Application by Highways England for an Order Granting Development Consent for A57 Link Roads

Deadline 8 - response on behalf of High Peak Borough Council

Responses from High Peak Borough Council are provided in red to outstanding matters discussed in the hearing session held during the week commencing 4th April 2022.

Figure 5.4 (Extract) - Air Quality Compliance Risk – A57 – High Peak Borough Council

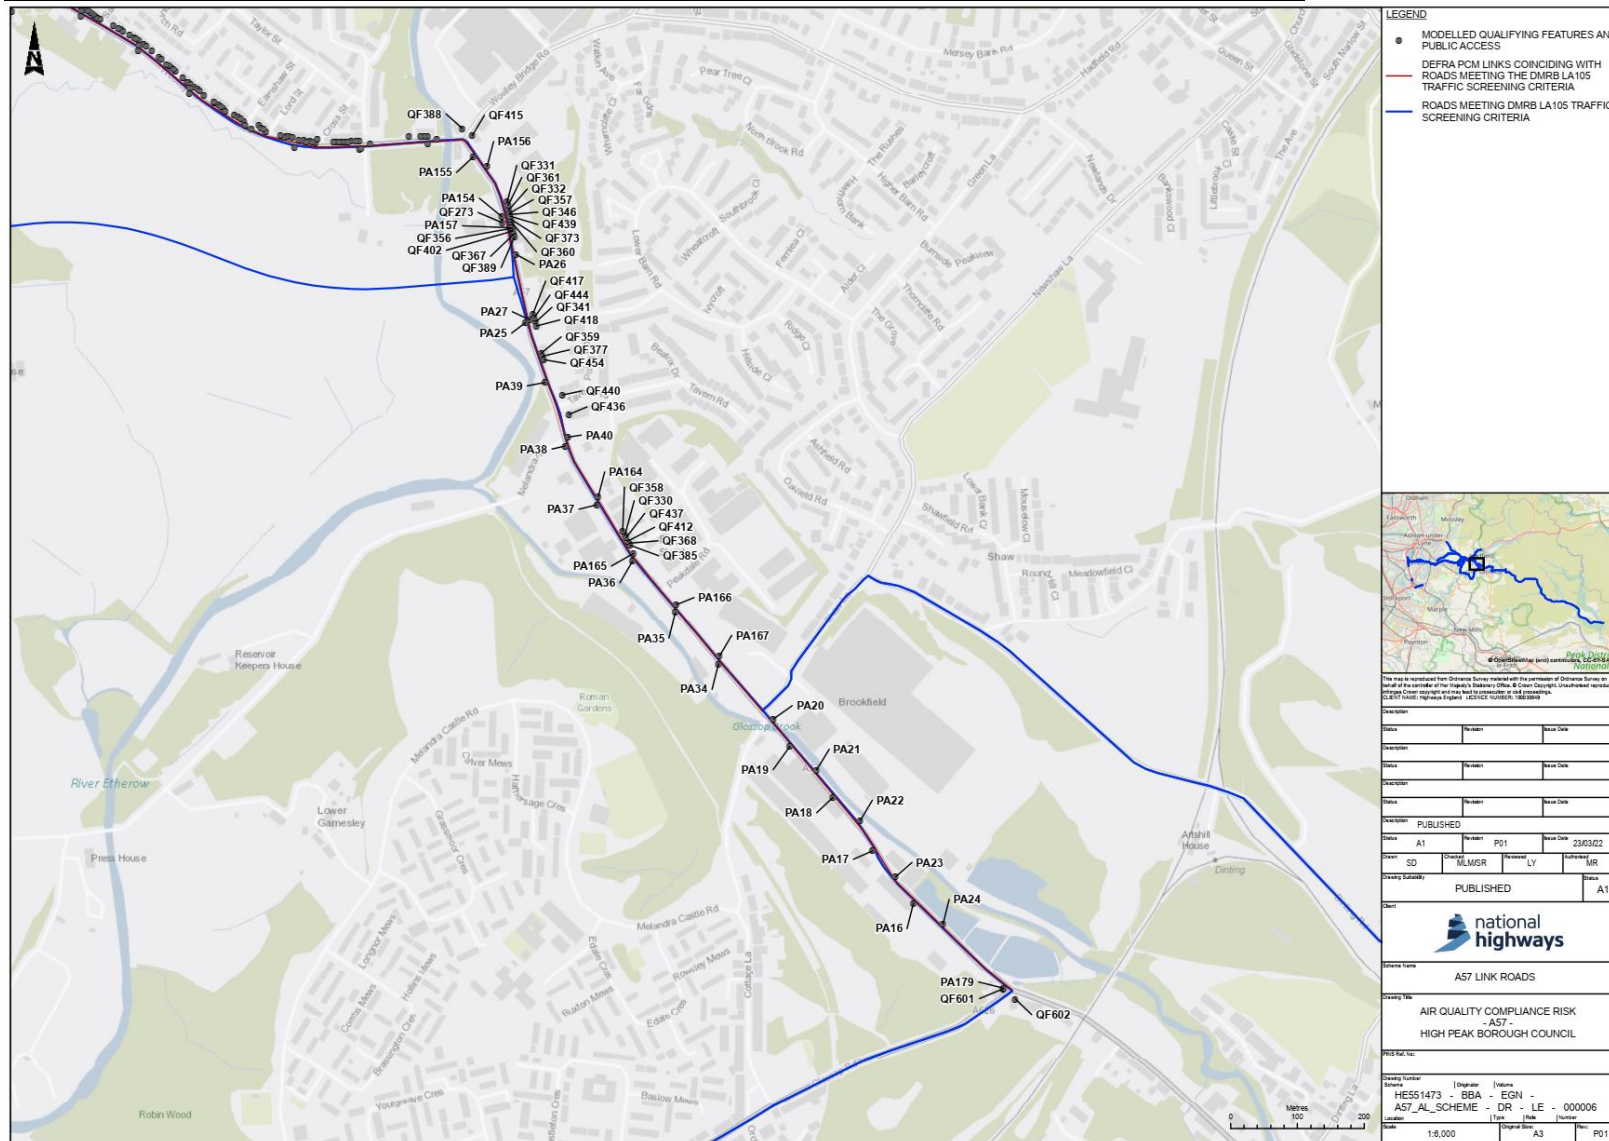
<u>Figure 5.4 Air Quality Compliance Risk Assessment – receptor labels</u>			
<p><u>Item 8.38</u> HPBC [REP4-011] asked for the A57 Brookfield qualifying features used in the NO2 compliance assessment to be</p>	<p>Given the number of qualifying features and public access receptors included in the compliance assessment it was not possible to practically label the qualifying features in ES Figure 5.4 (APP-080) however,</p>	<p>Agreed Deadline 8 update (HPBC) It is noted that this response was supplied at deadline 7 by NH. Clarification of receptors</p>	<p>Closed</p>

HPBC Item	National Highways Position	HPBC Position	Status
	<p>traffic scoping criteria requiring further assessment.</p> <p>The temporary traffic management measures will generally be short term, with the arrangements, timing and phasing being designed to minimise traffic congestion and delay far as reasonably practicable. Inevitably, however, some of the temporary traffic management arrangements are likely to cause some additional short term traffic congestion and delay within the immediate vicinity of the Scheme, but this is not anticipated to be sufficient to result in any material change in traffic flows or congestion on roads within HPBC.</p> <p>The approach to the assessment of the impact of construction traffic management has been further discussed and agreed with HPBC (virtual meeting held 4th March 2022).</p>		
<u>Human health receptors A57 Brookfield</u>			
<p><u>ISH 3 Item 5 Air Quality Question j</u></p> <p>Within the response to question j, HPBC raised a concern regarding the</p>	<p>Following further discussion and clarification with HPBC (virtual meeting held 8th April 2022) it has been agreed that a sensitivity test will be undertaken to identify the air quality impact at relevant qualifying</p>	<p>Deadline 8 update (HPBC) Further to Item 8.38; Identification of the receptors (figure 5.4) used in the compliance risk assessment</p>	<p>Open</p>

HPBC Item	National Highways Position	HPBC Position	Status
<p>magnitude of change reported in the compliance risk assessment at qualifying feature receptors adjacent to the A57 Brookfield.</p>	<p>feature receptors located adjacent to the A57 Brookfield under the DMRB LA 105 human health assessment methodology.</p>	<p>(using LAQM “conservative” forecast”) indicated that “large” change at some of the receptors along Brookfield. However, it also highlighted that some of these were human health receptors that had not been included as receptors in the (less conservative) primary human health AQ assessment (DMRB LA 105). Therefore, HPBC have requested that these receptors are also assessed in accordance with the DMRB LA 105</p>

HPBC Item	National Highways Position	HPBC Position	Status
labelled on ES Figure 5.4 [APP-080].	an extract of ES Figure 5.4 zoomed in on the A57 Brookfield area with receptor ID labels for qualifying features and public access receptors adjacent to the A57 Brookfield is provided below this table.	did highlight that there were some relevant receptors in the Brookfield area that had not been included in general AQ assessment but had been included in the compliance assessment (see final row)	
<u>Adjustment of Background Concentrations Data used in Air Quality Assessment</u>			
<p><u>Item 8.39</u></p> <p>HPBC raised concerns about the lack of adjustment to the background concentrations used in the air quality assessment. HPBC [REP4-011] suggest they are concerned about over representation of beneficial effects.</p>	<p>The HPBC query relates to the verification and adjustment of the Department for Environment, Food and Rural Affairs (Defra) mapped background concentrations. National Highways provided a response to question 8.39 in REP3-018. As stated in REP3-018, where the Defra background maps underpredict background monitoring data this could lead to a need to apply a higher adjustment factor in the air quality model verification. The higher the adjustment factor applied, the more conservative the results of the assessment given that the adjustment is applied to both the modelled total concentration with and without the Scheme, which has the effect of increasing the change in concentration. Where concentrations</p>	Agreed	Closed

European protected sites requiring nutrient neutrality strategic solutions

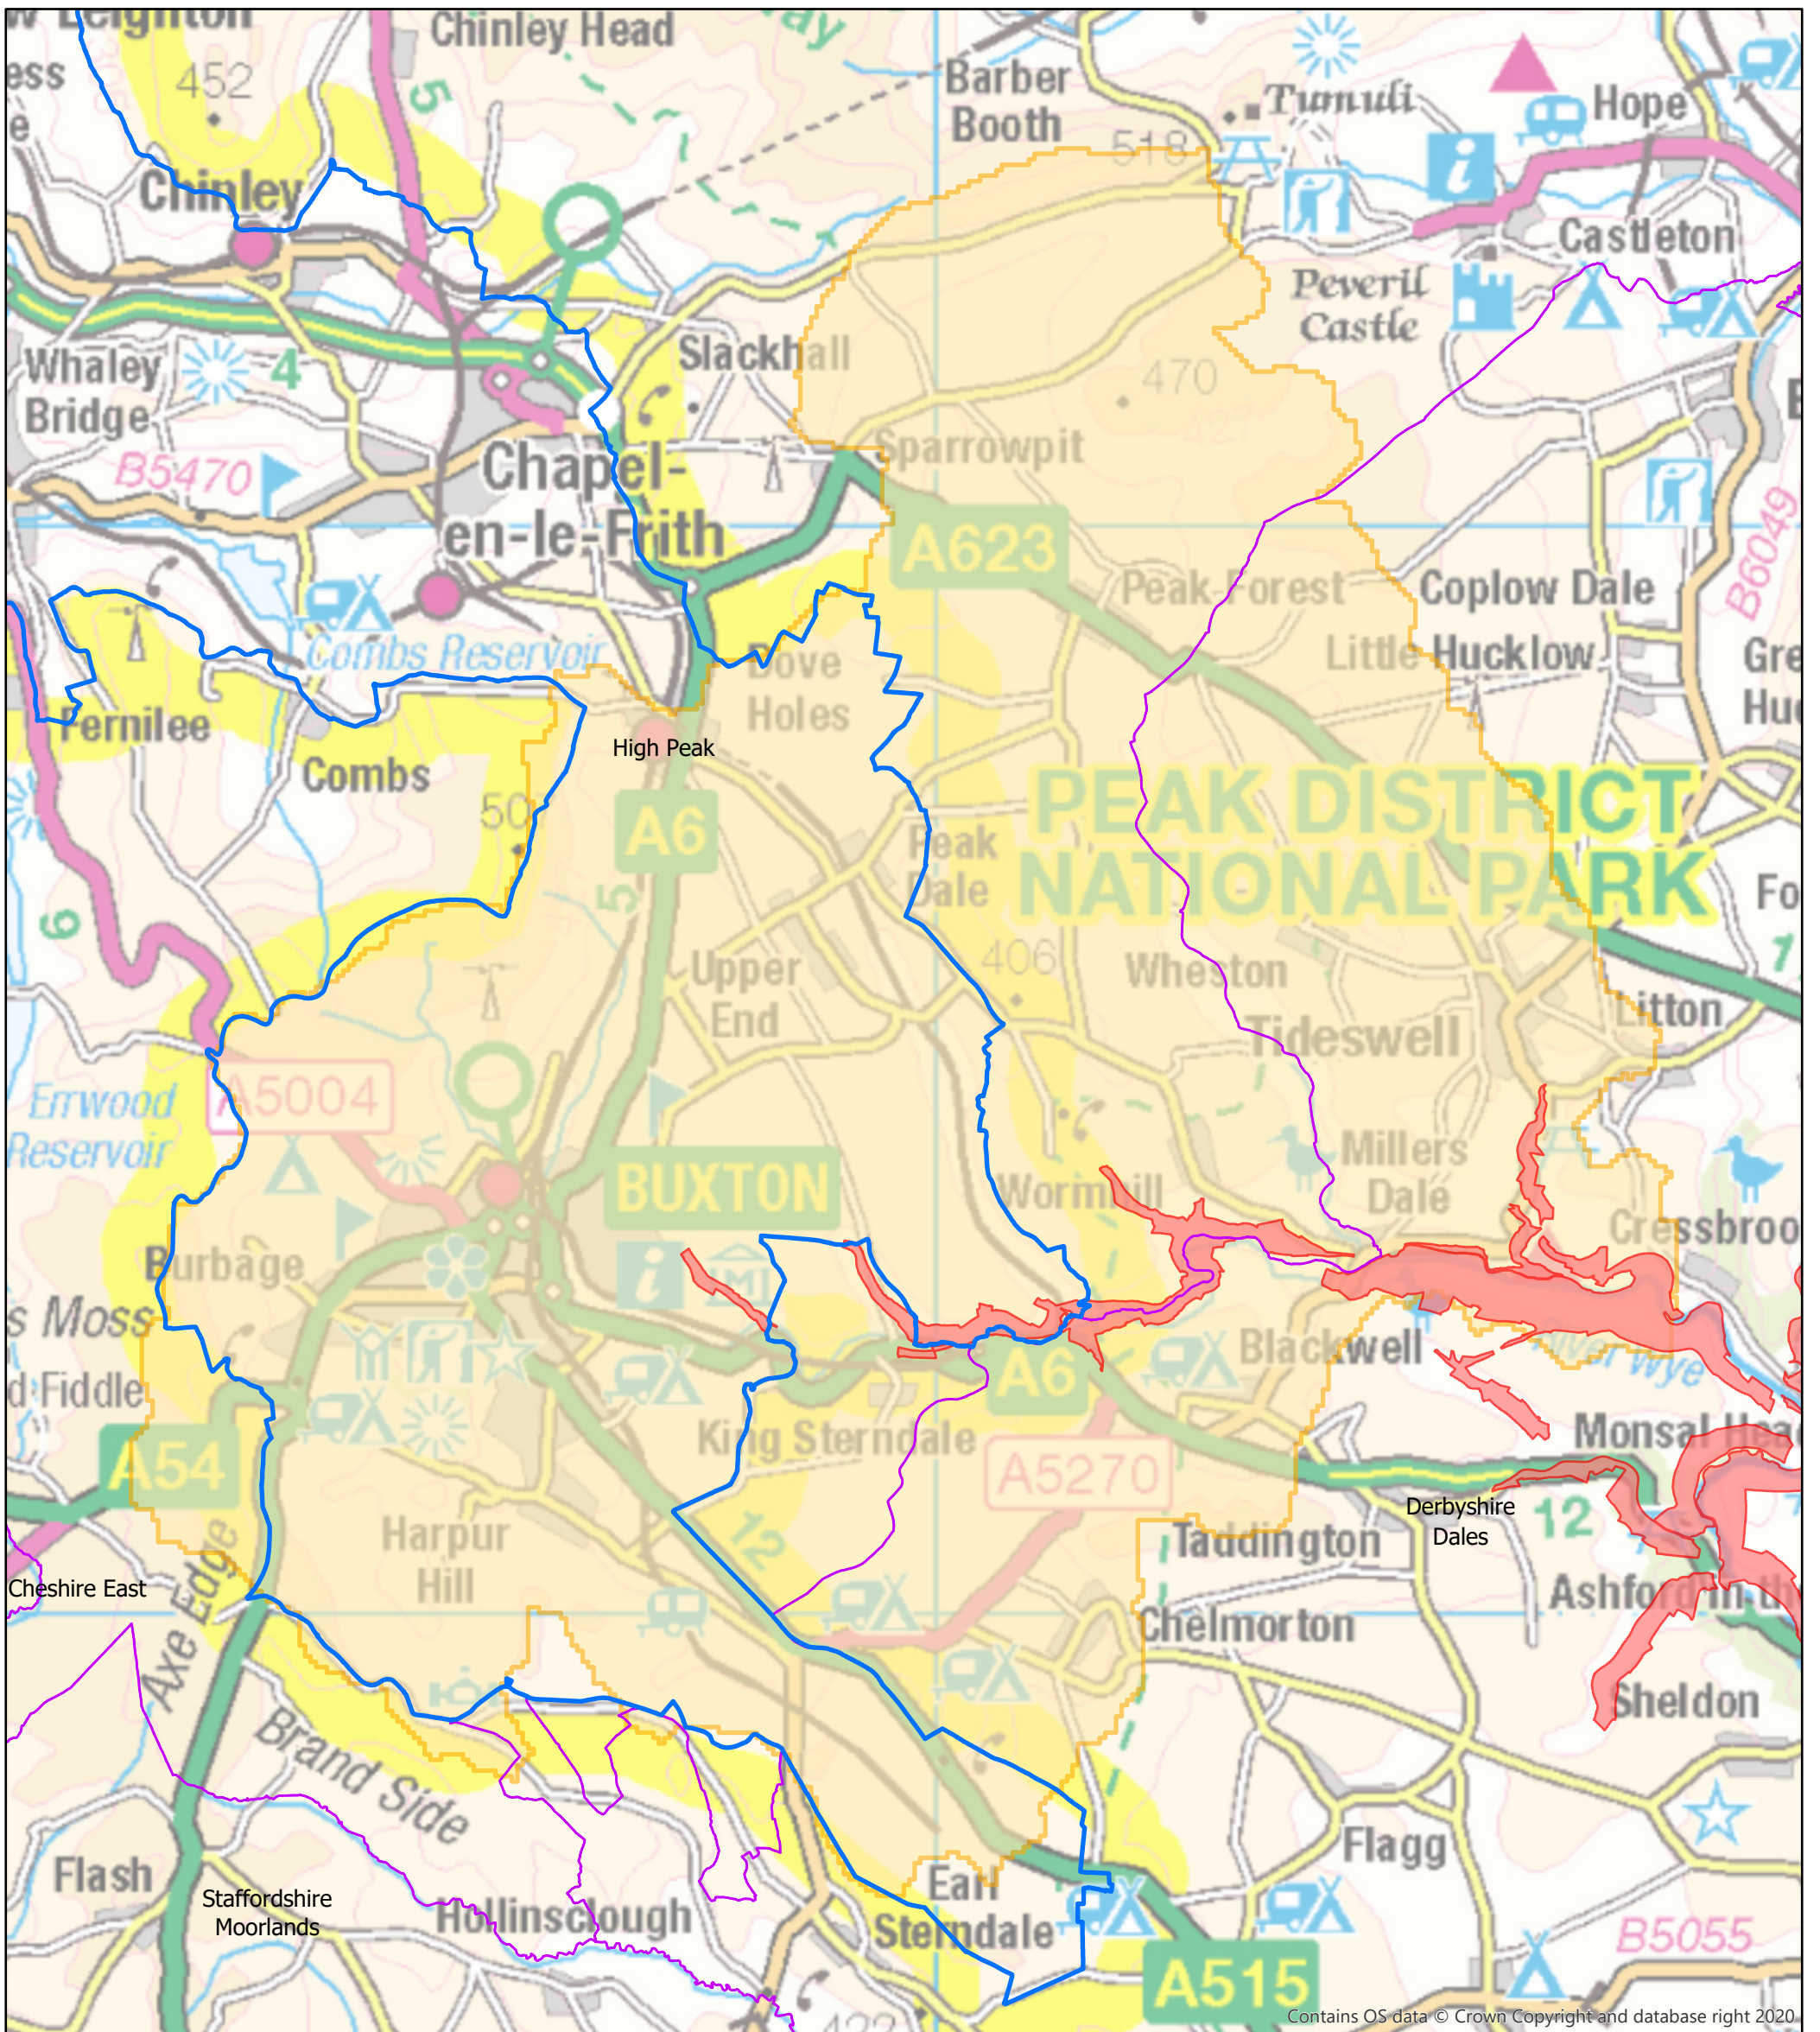
However, the advice relates specifically to the Peak District Dales Special Area of Conservation (SAC) which consists of the catchment of the River Wye and tributaries between Buxton and Bakewell where exceedances of phosphorus levels has led to the site being classified as being in a “unfavourable condition”

The A57 Link Roads scheme does not fall within the catchment which is approximately 12 miles to the south. A plan of the catchment is enclosed.

As such, High Peak Borough Council does not believe that Natural England’s advice in relation to nutrient neutrality has any implications for the scheme. Natural England may wish to confirm this separately.
